Submitted by the expert from CLEPA

Assessment of UN Regulations under the purview of GRSG with regards to UI

R43

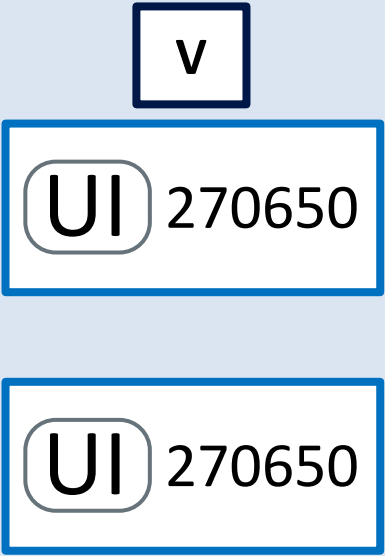
Using UI on the device

No added value

Missing important  
information for quality  
control and for easy  
identification on  
production/assembly  
site

Additional marking to identify the type of glass  
(e.g. toughened, laminated, plastic, < 70%, ...)
